Smithybridge Pub

Drainage system

WATER AUTHORITY CONSULTATION

Subject: FW: Pre Development Enquiry - Former Smithybridge Pub, 43 Smithy Bridge Rd, Littleborough OL15 0DY - UU ref 4200037735

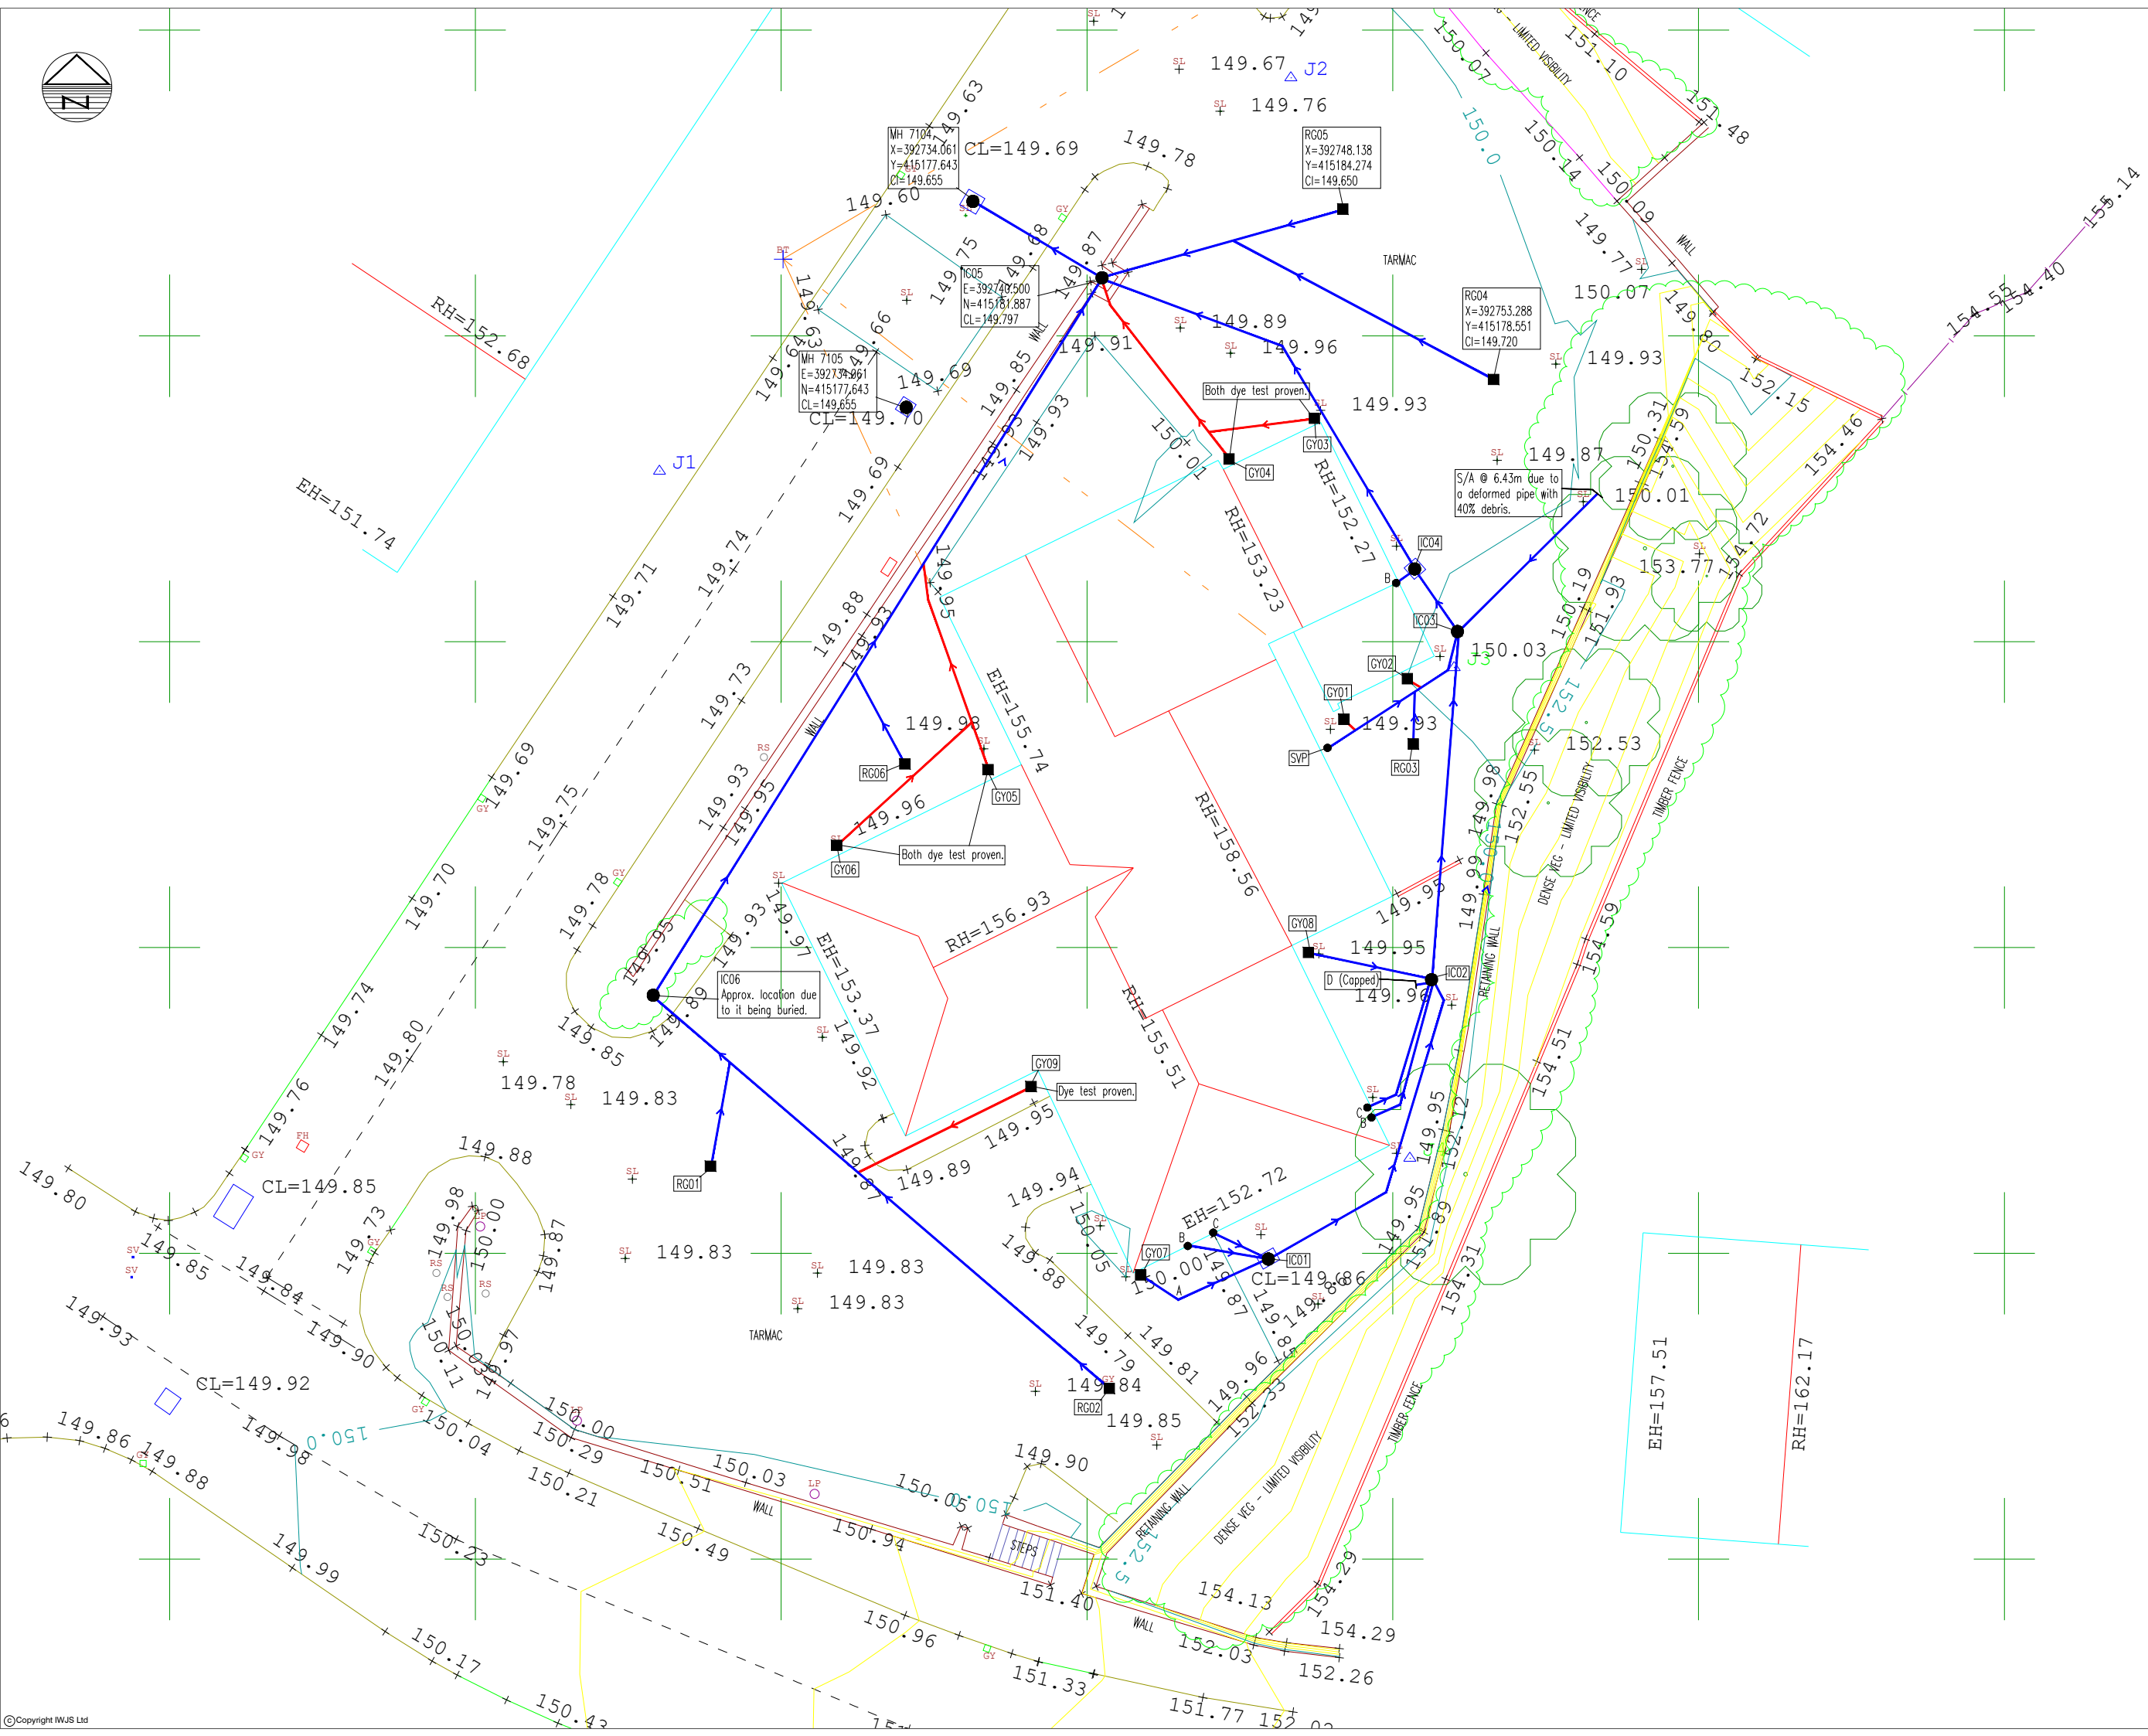
Thank you for your email and for providing the survey plan and soakaway feasibility report. Please see comments below:

Thank you for providing the existing drainage survey plan. If the above options are fully discounted, I confirm United Utilities would be happy for foul and surface water to utilize the existing connection (to the 300mm public combined sewer).

In light of the below I confirm United Utilities would deem a surface water connection to the 300mm public combined sewer (at a restricted rate of 12.3 l/s, as discussed previously) would be acceptable.
